CHATTAHOOCHEE RIVERLANDS GREENWAY STUDY

SUB-AREA COMMITTEE MEETINGS SUMMARIES AND DIGITALLY SUBMITTED COMMENTS

SUBMITTED ON 11/5/2019

MAP L-115: ALIGNMENT ALTERNATIVES SUMMARIZED NOTES

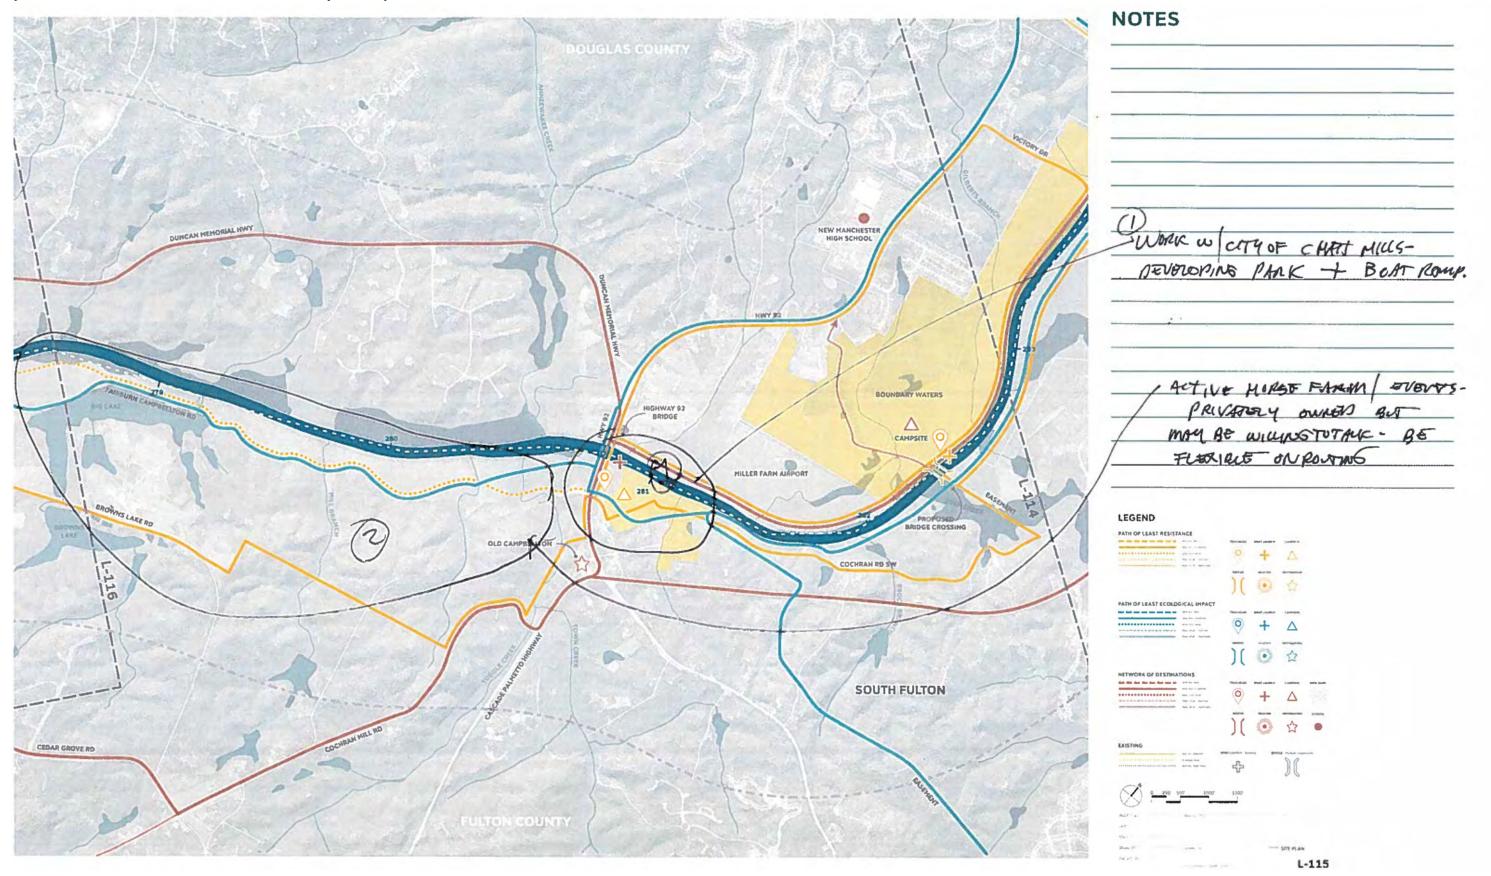
- There is not a lot / enough room to fit multiuse trail on existing bridge – mind need to consider parallel or cantilevered structure
 - Alternate location proposed in SAC document

MAP L-116: ALIGNMENT ALTERNATIVES SUMMARIZED NOTES

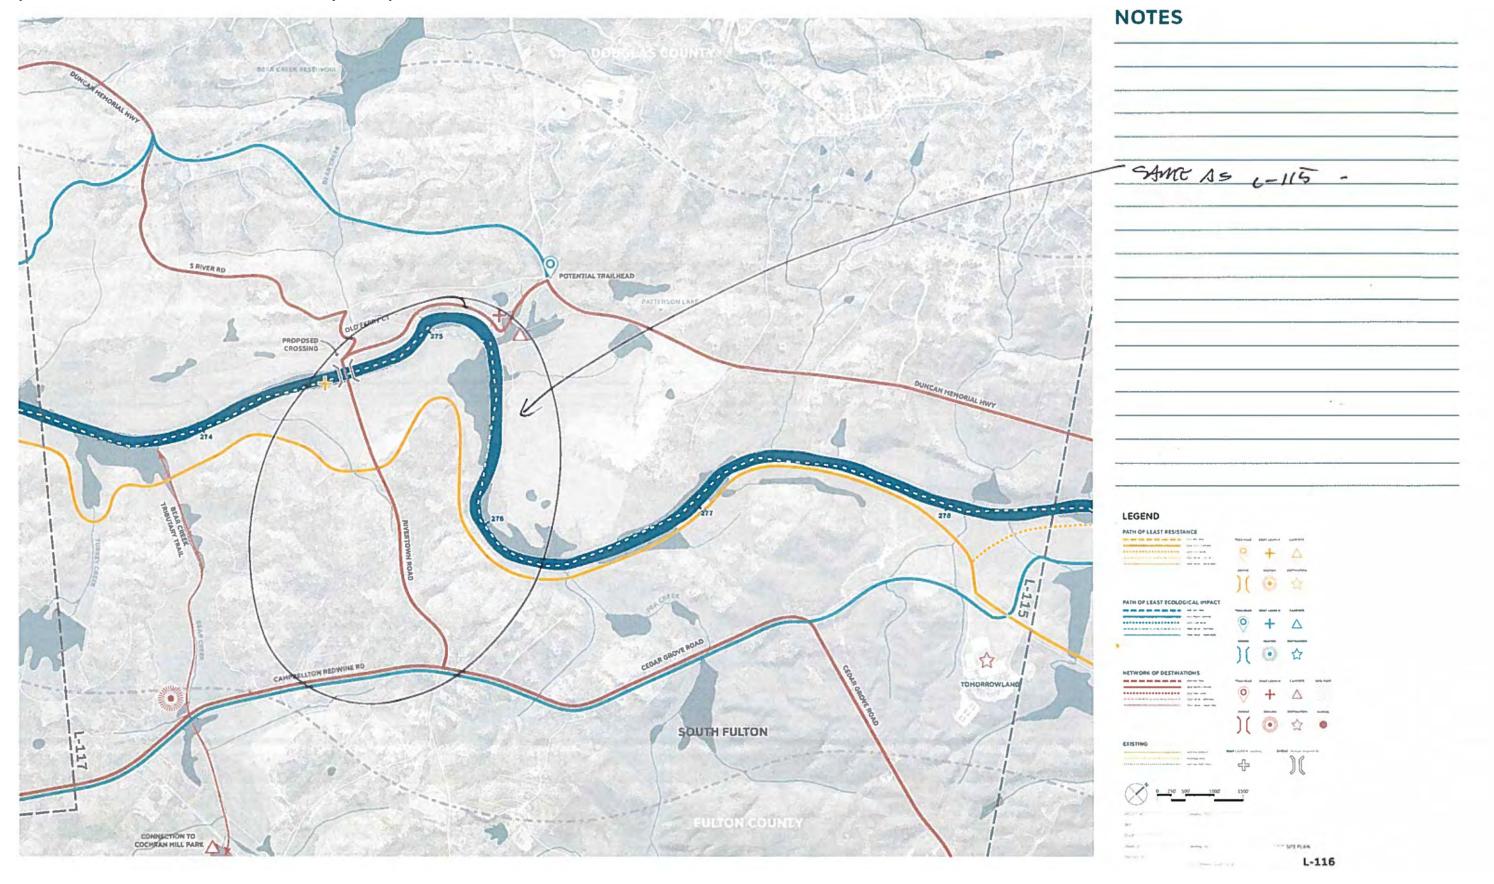
- Lease Resistance path along East Side of the River seems like preferred option
- Landowner's master plan includes potential tri-athelete training facility which will include 14 miles of multi-use trails, much of which aligns with the path of least resistance leading up towards Campbellton Park.
 - Developer would be the primary partner in achieving this alignment with the understanding that any path system along the river MUST be accessible to the public.
 - Landowner intends for trail system along the Bear Creek tributary (through the water authority property) to connect back to Cochran Mill Park.
- Public greenspace is also being considered at the proposed crossing (pumpkin town). This would be ideal for a crossing and historic site.

MAP L-117: ALIGNMENT ALTERNATIVES SUMMARIZED NOTES

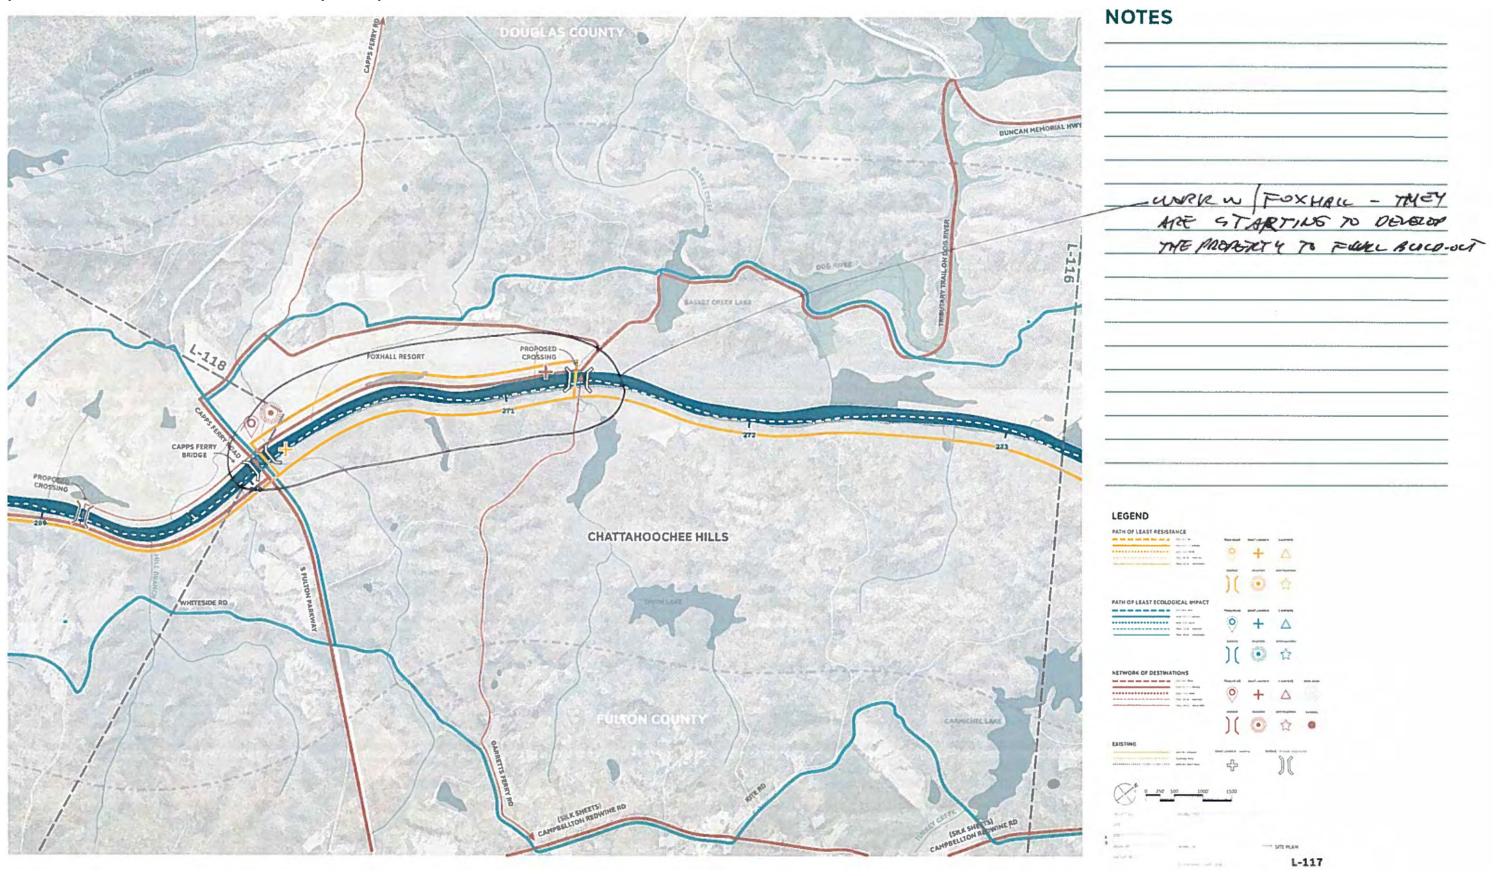
- Path of Least Resistance is preferred up to Capps Ferry Road
- Make sense to stay on Whiteside road in the short term
- Bikelane needed on South Fulton / Capps Ferry Crossing and path alignment achievable via right of way with City of Chattahoochee Hills

MAP L-119: ALIGNMENT ALTERNATIVES SUMMARIZED NOTES

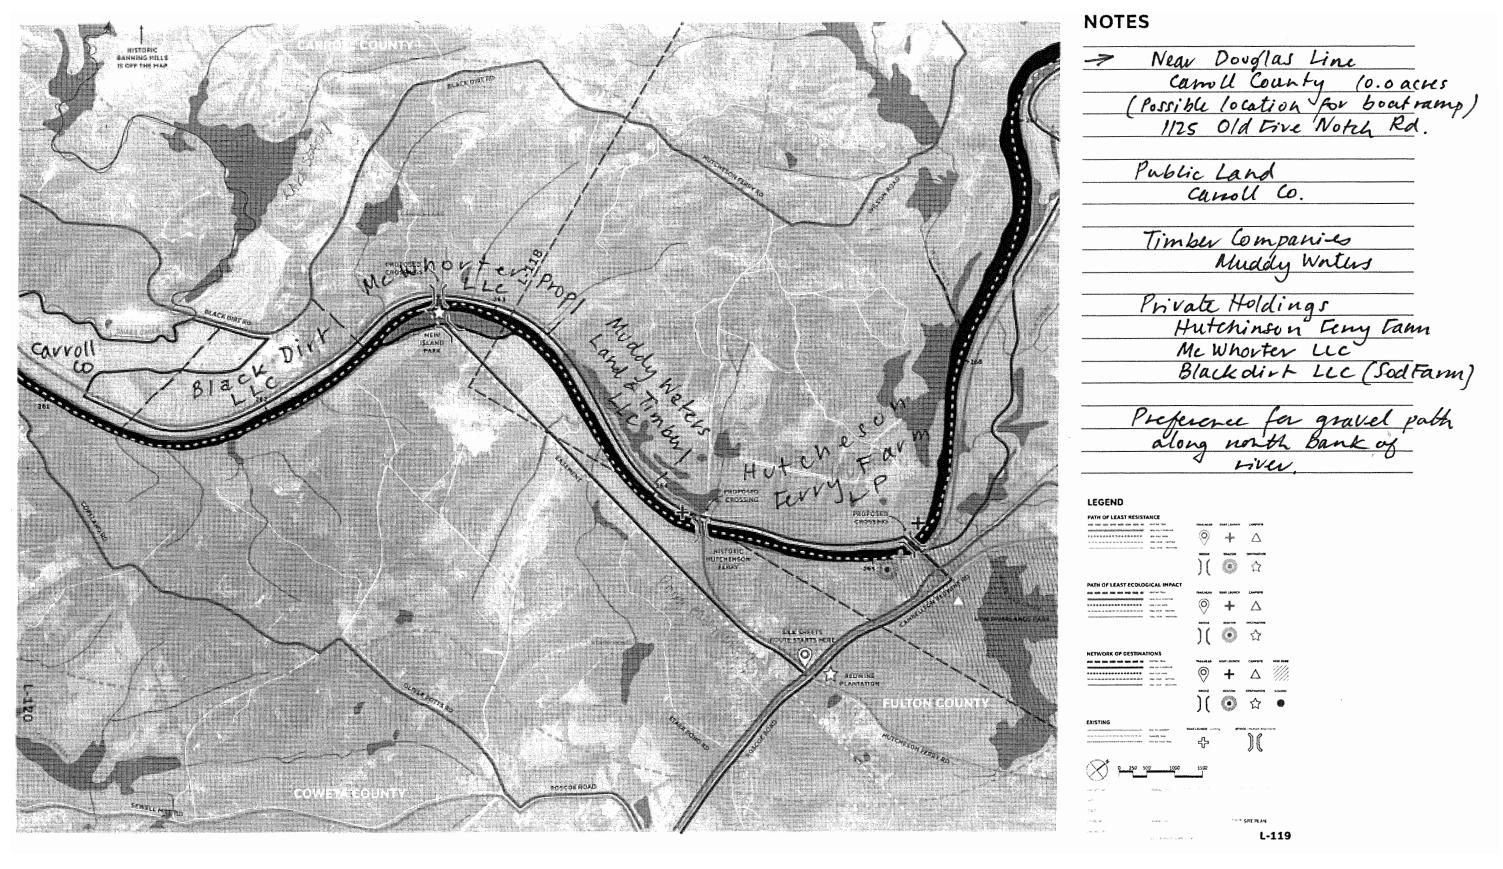
- Path of least resistance on western bank of river follows alignment with the most civic minded landowners.
- Black Dirt Road (Eco option) is already spectacular for biking and cycling
- FoMR prefers "a gravel path along North (west?) bank of the River."

MAP L-120: ALIGNMENT ALTERNATIVES SUMMARIZED NOTES

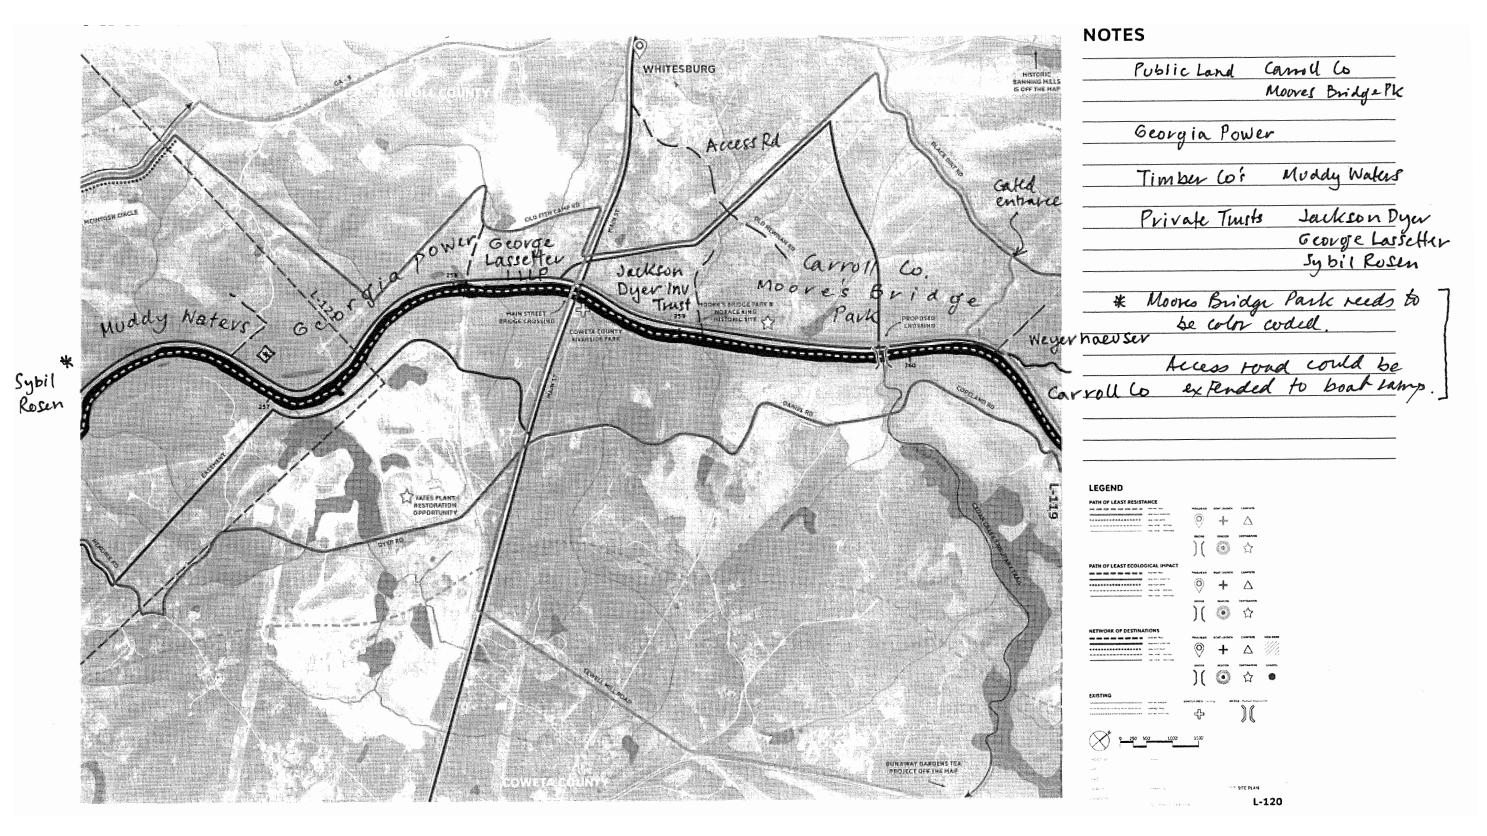
- Main Street very dangerous / terrible for bikes
- Daniel Road and Black Dirt Road are appealing cycling roads
- Potential for a pedestrian bridge at the location of the historic Moore's Bridge to connect to Carroll County Park on Eastern Bank of the River
- FoMR Access road along Old Newnan Road could be extended to boat ramp on River
